Planning Commission Staff Report

Subject: Treasure
Project #: PL-08-00370
Authors: Francisco Astorga, AICP, Senior Planner
Date: 25 October 2017
Type of Item: Administrative – Conditional Use Permit Refinement 17.2 Update

During the [October 11, 2017](#) Planning Commission meeting, the Commission requested that the Planning Department to provide an analysis of Refinement 17.2 and the Plans provided on the Sweeney Properties Master Plan (SPMP) produced by Eugene Woodruff. Staff prepared the following exhibits to allow the Planning Commission to compare the original SPMP approval plans/documents (Master Plan/Woodruff) and Refinement 17.2:

CREOLE SITE SAMPLE ELEVATIONS
 SWEENEY PROPERTIES MASTER PLAN

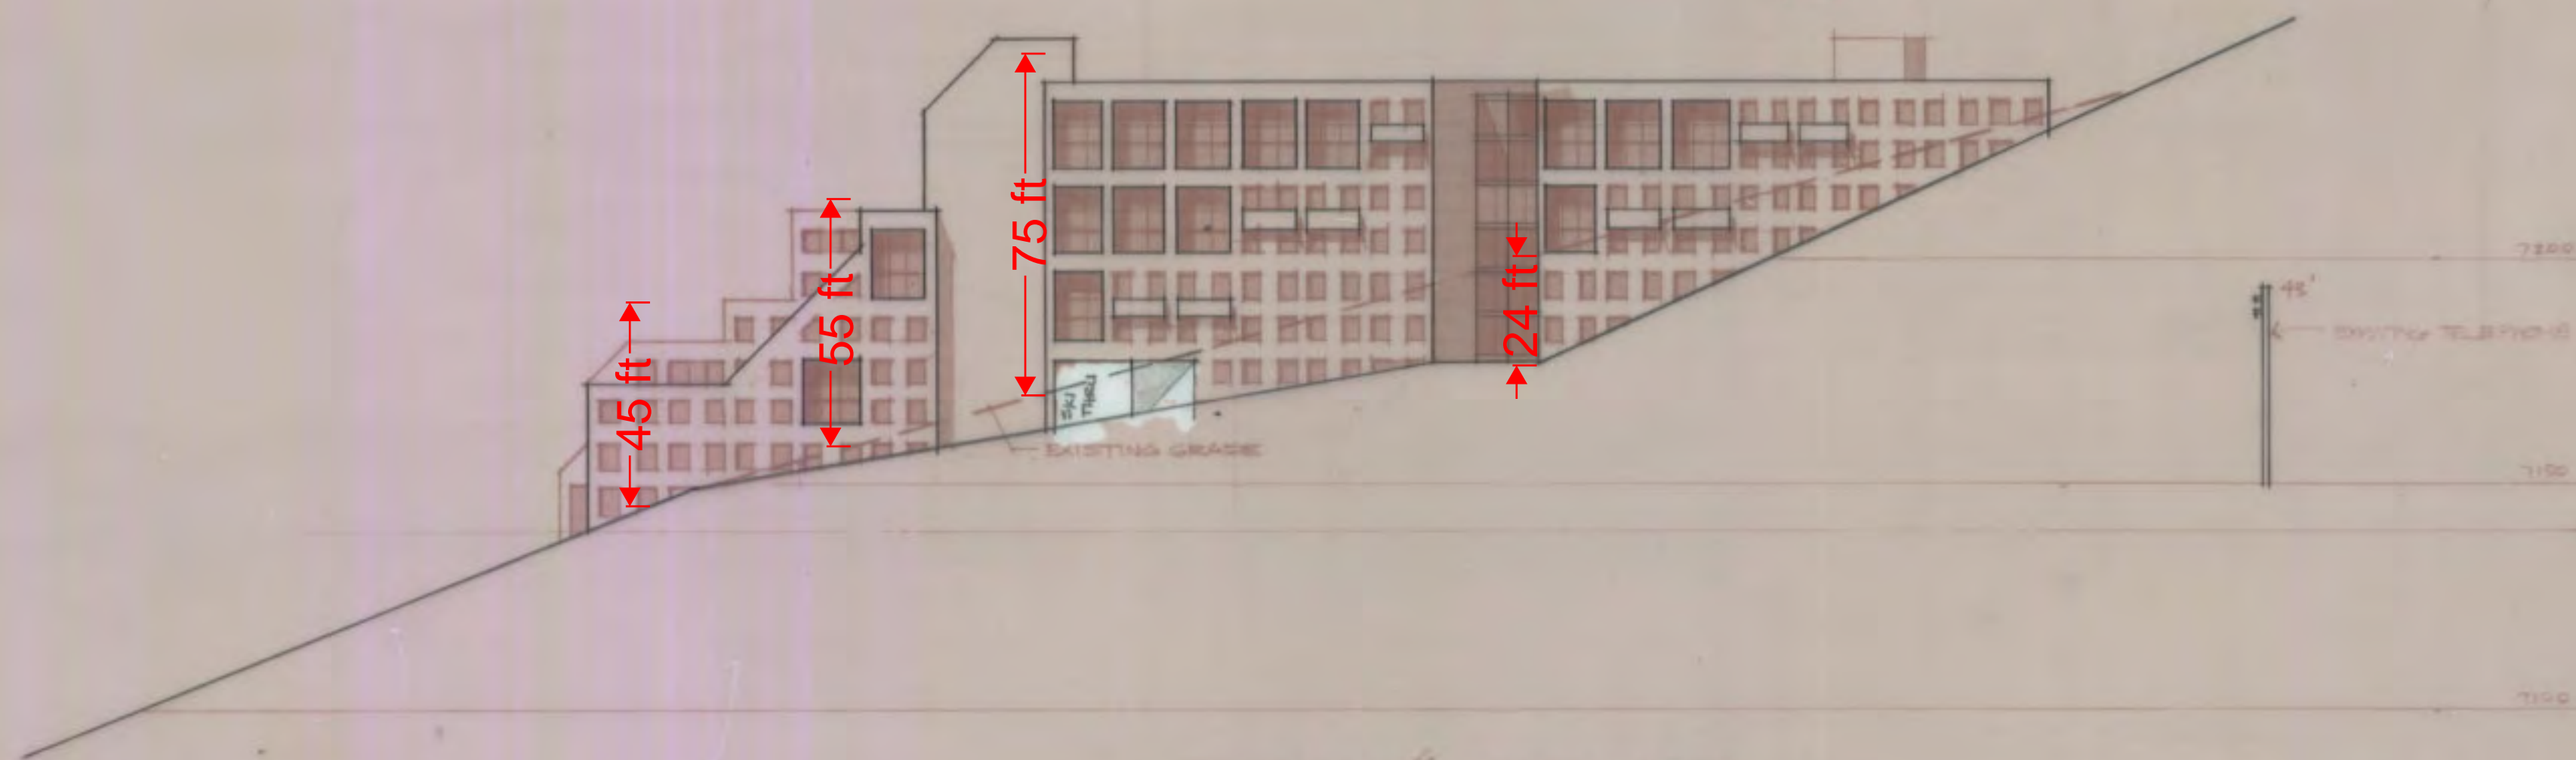
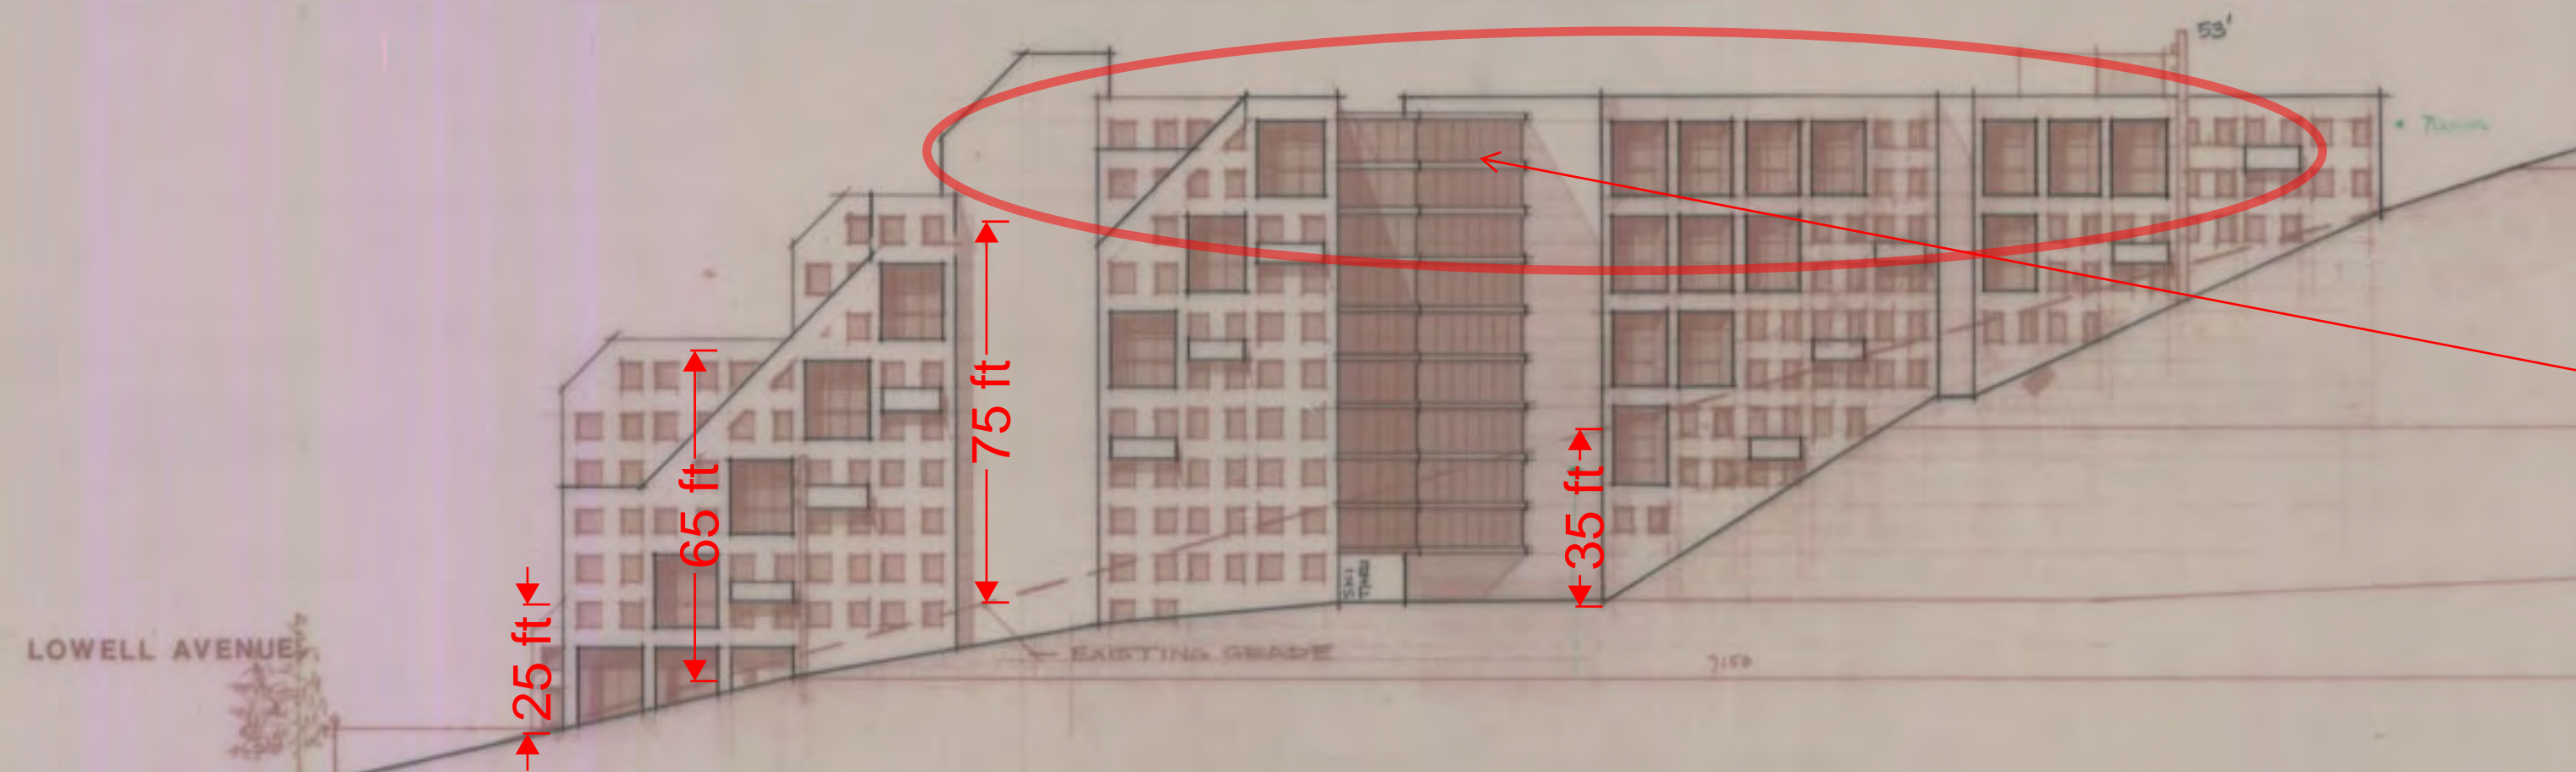
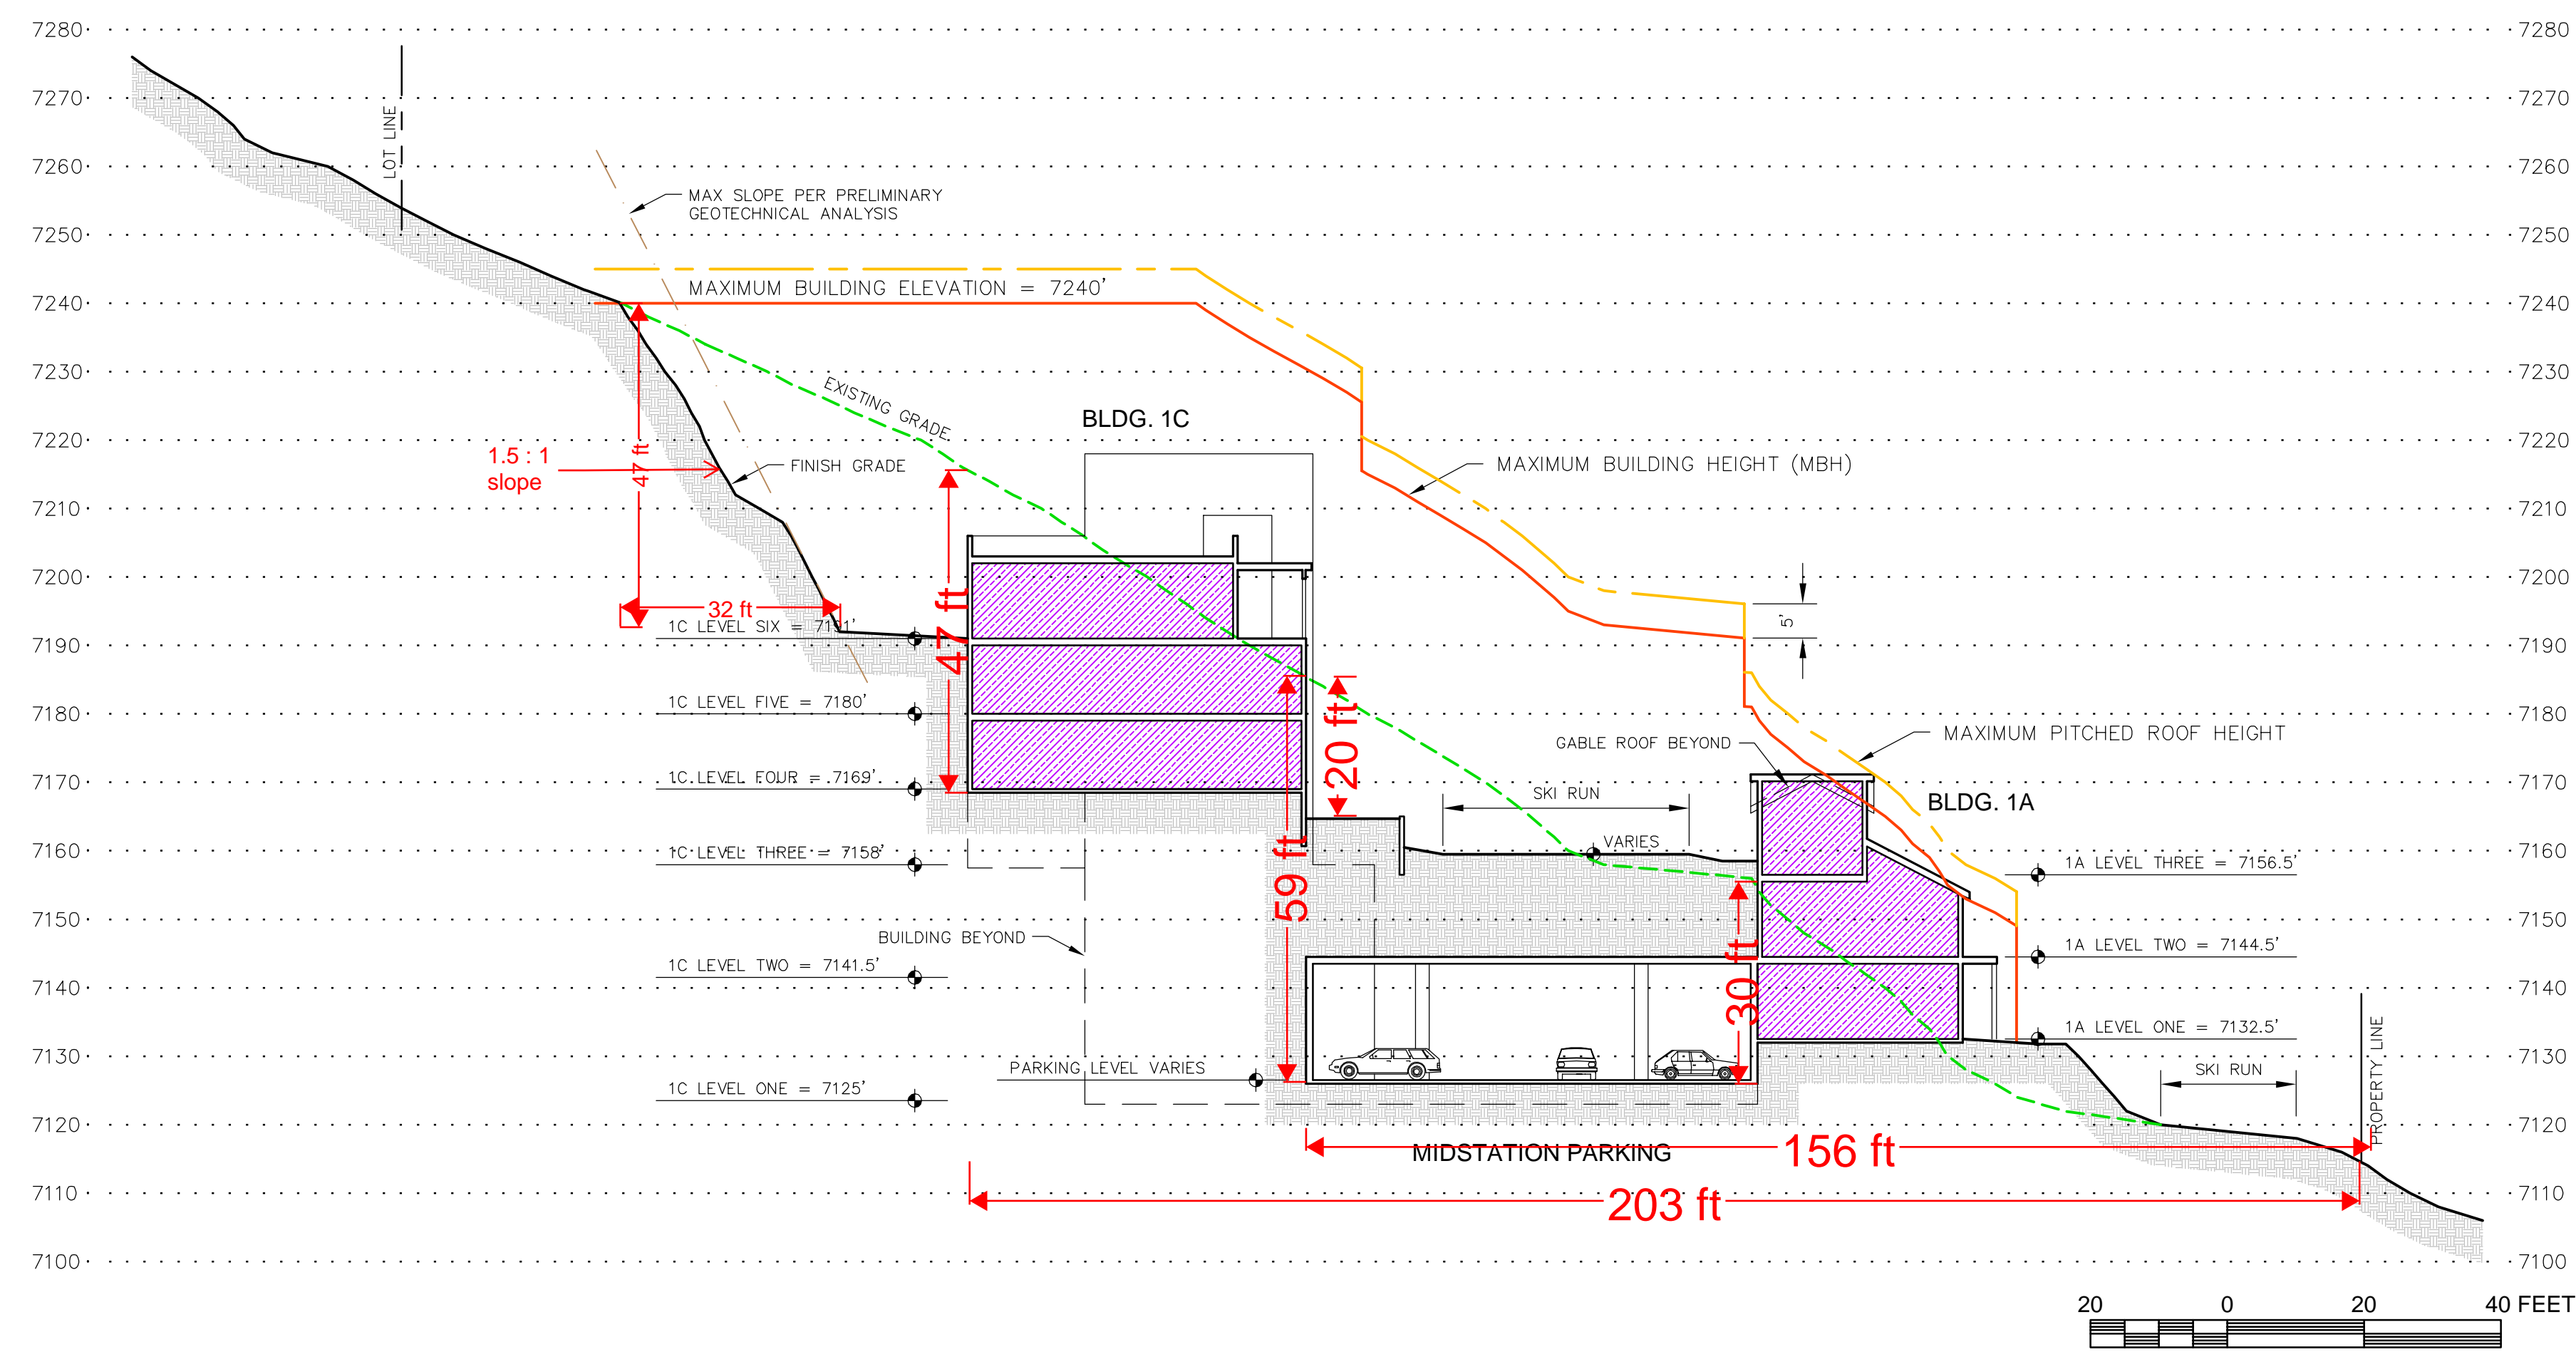
22. Building C, D, and E elevations show re-grading existing grade as final grade is shown around the periphery of the building.
23. Building C existing grade is taken down approximately 24 feet towards the middle of the building at the periphery of the structure; see sheet 24.

24. Building D existing grade is taken down approximately 35 feet towards the middle of the building at the periphery of the structure; see sheet 24.
25. Building E existing grade is taken down approximately 25 feet towards the middle of the building at the periphery of the structure; see sheet 24.

27. Sample elevation C and E show compliance with the building sections/height zone plan, measured from existing grade. Sample elevation D was not updated/amended to show the adopted height as the change is indeed reflected on the building section sheet 17 and height zone plan sheet 22.
28. Sheet 28 and 29 show each ski run bi-furcating its corresponding site as well as the development boundaries.

TOP OF BUILDING NOT UPDATED TO REFLECT APPROPRIATE HEIGHT AS CHANGED & SHOWN ON BLDG. SECTION D ON SHEET 18 OR REFLECTED ON HEIGHT ZONES SHEET 22
